SHEET TITLE
**PHASE 2
ZONING PLAN**

PETITION NO: Z-37

ZONING COMMENTS:

The applicant is requesting the NRC zoning category in order to make the subject property consistent with its previously zoned property from February 2010 (Z-5), across Acworth-Dallas Road. The applicant is requesting the NRC district to develop retail and restaurant uses along with an open air park to be consistent with the bank and retail center from the previous zoning case. The buildings will be one-story with traditional building architecture featuring brick and stucco. The retail buildings will lease to small retail, office, and restaurant uses. The hours and days of operation will vary depending on the final user. The applicant has submitted the attached Zoning Impact Analysis for your review.

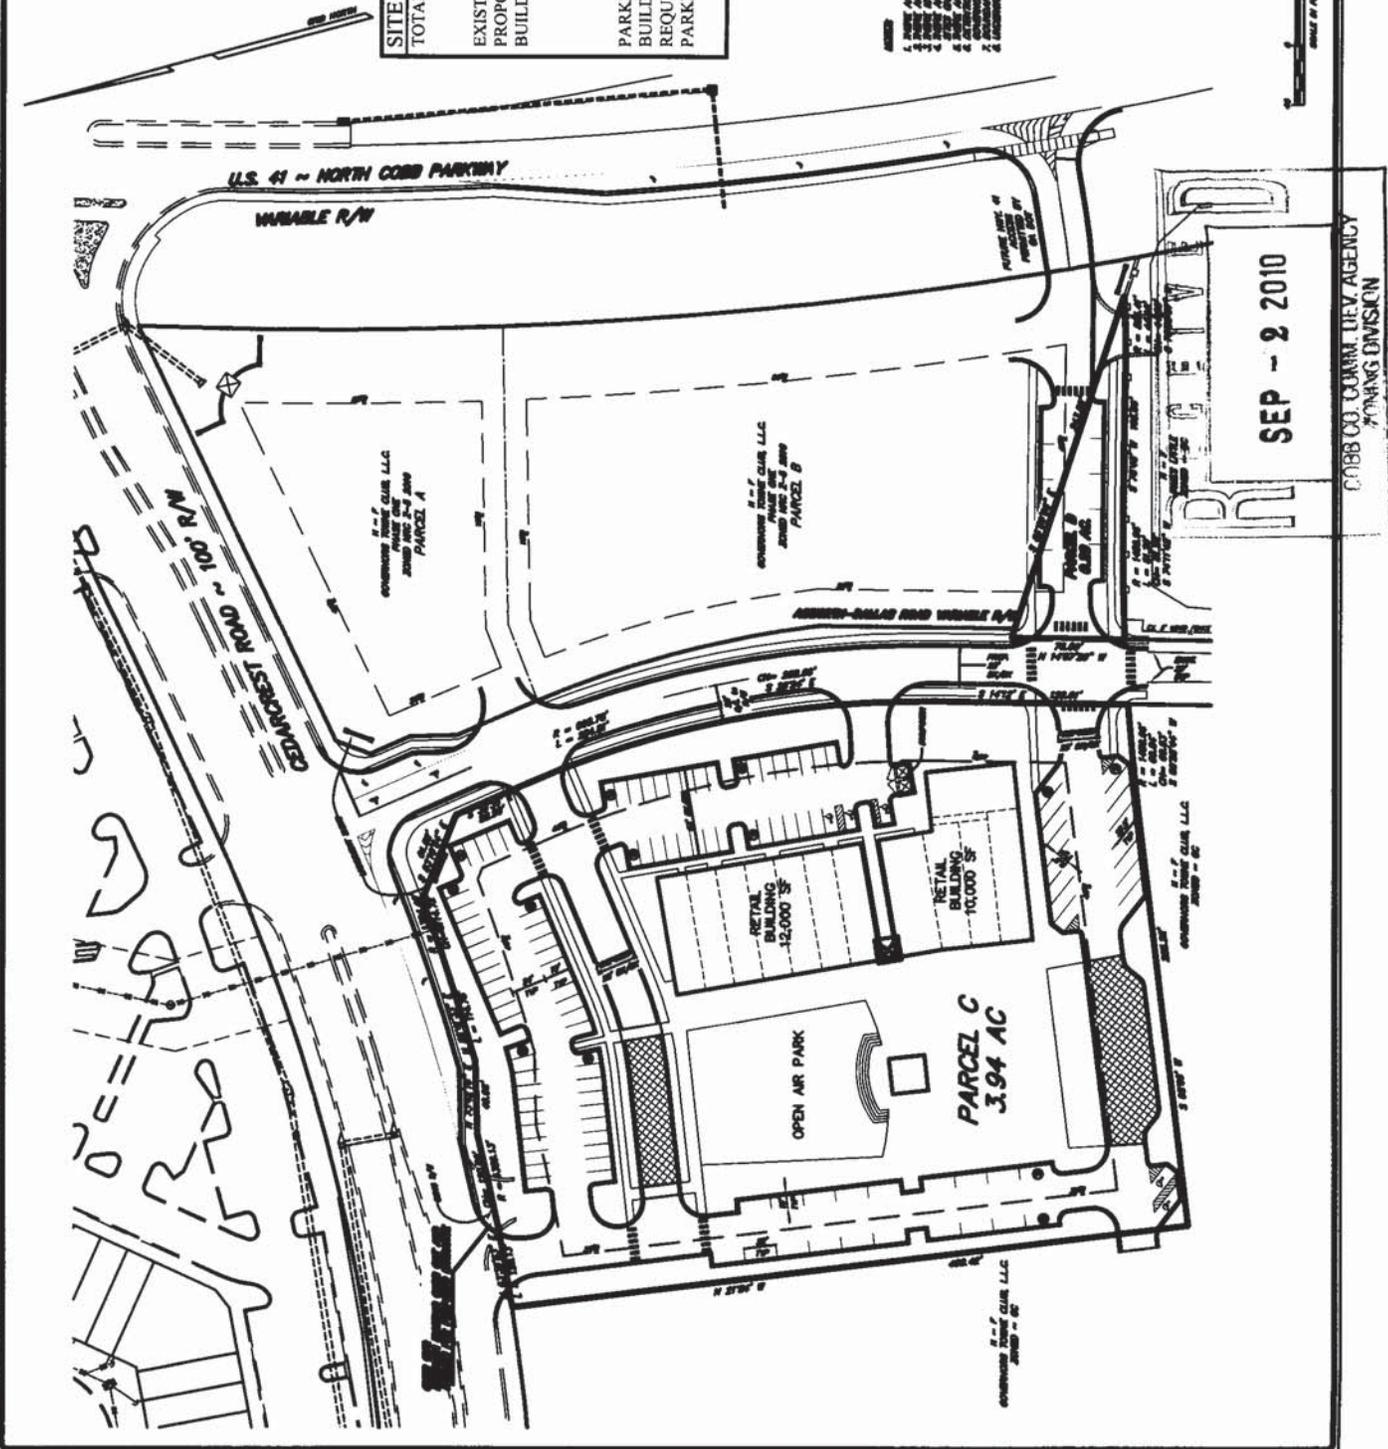
- No Stormwater controls shown _____
- Copy of survey is not current - Additional comments may be forthcoming when current site conditions are exposed.
- No site improvements showing on exhibit.

As necessitated by this development for egress from Cedarcrest Road, a deceleration lane will be required for western driveway.

Install sidewalk along Cedarcrest Road frontage.

Install curb and gutter along both sides of Acworth Dallas Road.

Install sidewalk along the east side of Acworth Dallas Road frontage.

Recommend deceleration lane along Cedarcrest Road for western driveway.

Recommend installing sidewalk along Cedarcrest Road frontage.

Recommend installing curb and gutter on both sides of Acworth Dallas Road frontage.

Recommend installing sidewalk along the east side of Acworth Dallas Road frontage.

- Site plan received by the Zoning Division September 2, 2010, with the District Commissioner approving minor modifications;
- District Commissioner approving the building architecture;
- Fire Department comments and recommendations;
- Water and Sewer comments and recommendations;
- Stormwater Management comments and recommendations; and
- DOT comments and recommendations.
